### Appeal No. A-3-MRA-19-0034 & Coastal Permit No. 9-20-0603

## CORRESPONDENCE

#### Re: <u>Monterey Peninsula Water Supply Project, CDP Application No. 9-20-0603 &</u> Appeal No. A-3-MRA-19-0034: Impact on Customer Rates

Figure 6-7. Groundwater Elevations in PZ-1 Cluster, MW-4S, and MW-7S\* Larger Version Attached

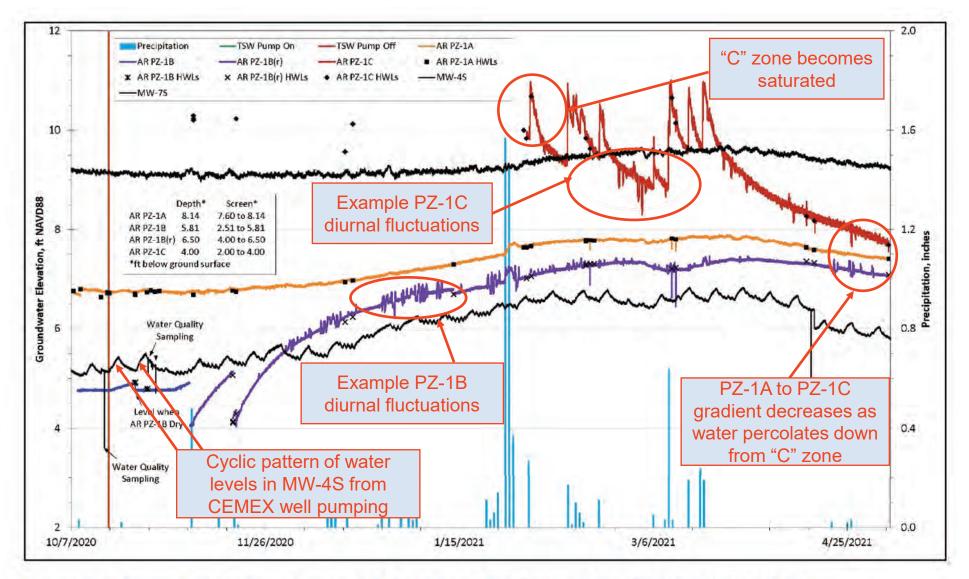
# **GSS Figure 6-7 Annotations**

Figure 6-8. Groundwater Elevations in PZ-2 Cluster, MW-4S, and MW-7S\* Larger Version Attached

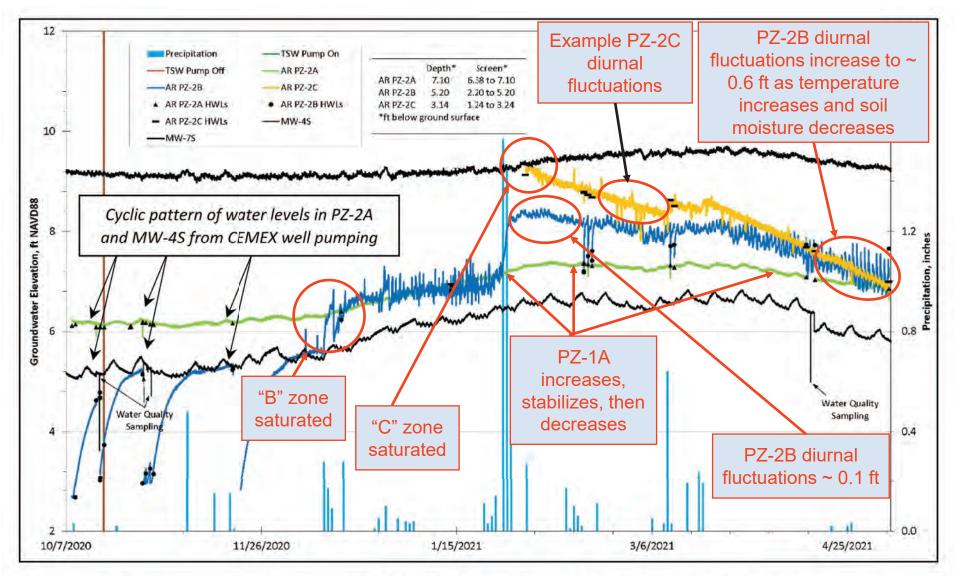
# **GSS Figure 6-8 Annotations**

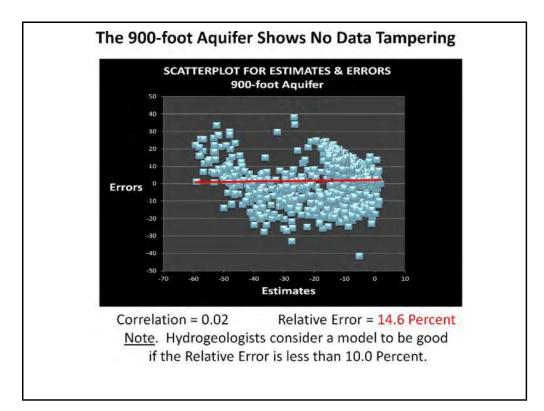
The modeling consultants Geoscience and HydroFocus used calibration—the adjustment (tampering?) of predictor data—to reduce error variation to an acceptable range. As I have indicated in filed comments on the EIR as early as 2015, Geoscience failed in that attempt with the 180-foot aquifer: The relative error for that aquifer was 11.2%, outside the acceptable range of zero to 10. See the figure below.

HydroFocus dealt with that problem by raising the upper limit of the acceptable range from 10 to 15 though for a bell-shaped error distribution 15 is 90 percent of the highest practical value (16.7%) for the relative error, a value indicating zero model predictive power.

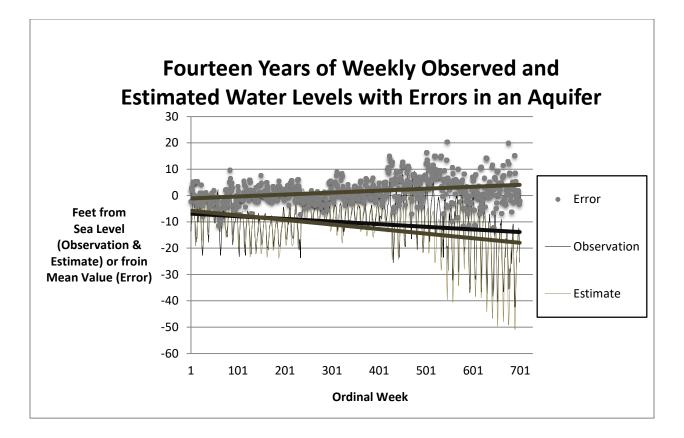
HydroFocus used the following graph (Figure 4.3d in Appendix E2 of the 2017 EIR) to illustrate its contention that the non-zero correlation between estimates and errors was caused by the model's inability to catch up with falling water levels:

This graph shows water-level measurements (grey line) and their estimates (black line) trending downward over time while errors (open circles) trend downward, as well, from positive to negative, showing a positive correlation between errors and both the observed measurements and their estimates. How could that be when the actual correlation is negative (-0.45), suggesting an upward error trend, as shown in the graph below, which is the first figure in the second linked article in the petition?

Here, appropriately, the errors trend upward while both the water-level observations and their estimates trend downward, correctly reflecting the negative error-estimate and observation-estimate correlations.

So, what explains the discrepancy between the two graphs? The description of the vertical scale for errors (residuals) on the right side of the HydroFocus graph suggests the answer: "Model-calculated - Measured." That is the opposite of what it should be, as shown in the equation below:

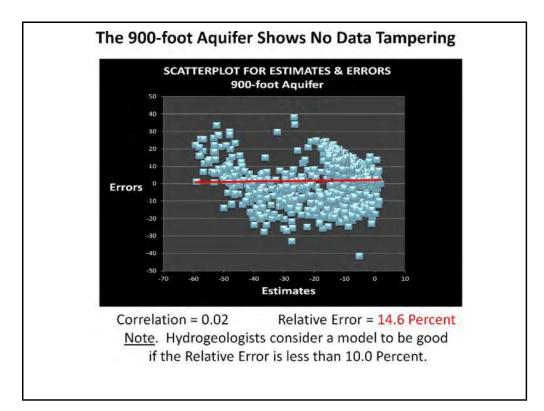
The modeling consultants Geoscience and HydroFocus used calibration—the adjustment (tampering?) of predictor data—to reduce error variation to an acceptable range. As I have indicated in filed comments on the EIR as early as 2015, Geoscience failed in that attempt with the 180-foot aquifer: The relative error for that aquifer was 11.2%, outside the acceptable range of zero to 10. See the figure below.

HydroFocus dealt with that problem by raising the upper limit of the acceptable range from 10 to 15 though for a bell-shaped error distribution 15 is 90 percent of the highest practical value (16.7%) for the relative error, a value indicating zero model predictive power.

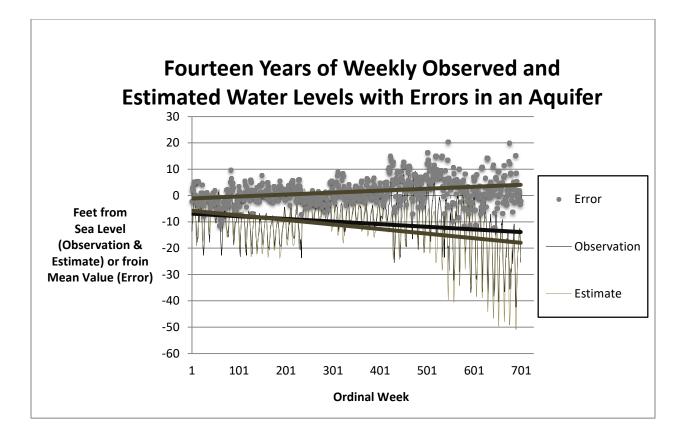
HydroFocus used the following graph (Figure 4.3d in Appendix E2 of the 2017 EIR) to illustrate its contention that the non-zero correlation between estimates and errors was caused by the model's inability to catch up with falling water levels:

This graph shows water-level measurements (grey line) and their estimates (black line) trending downward over time while errors (open circles) trend downward, as well, from positive to negative, showing a positive correlation between errors and both the observed measurements and their estimates. How could that be when the actual correlation is negative (-0.45), suggesting an upward error trend, as shown in the graph below, which is the first figure in the second linked article in the petition?

Here, appropriately, the errors trend upward while both the water-level observations and their estimates trend downward, correctly reflecting the negative error-estimate and error-observation correlations.

So, what explains the discrepancy between the two graphs? The description of the vertical scale for errors (residuals) on the right side of the HydroFocus graph suggests the answer: "Model-calculated - Measured." That is the opposite of what it should be, as shown in the equation below:
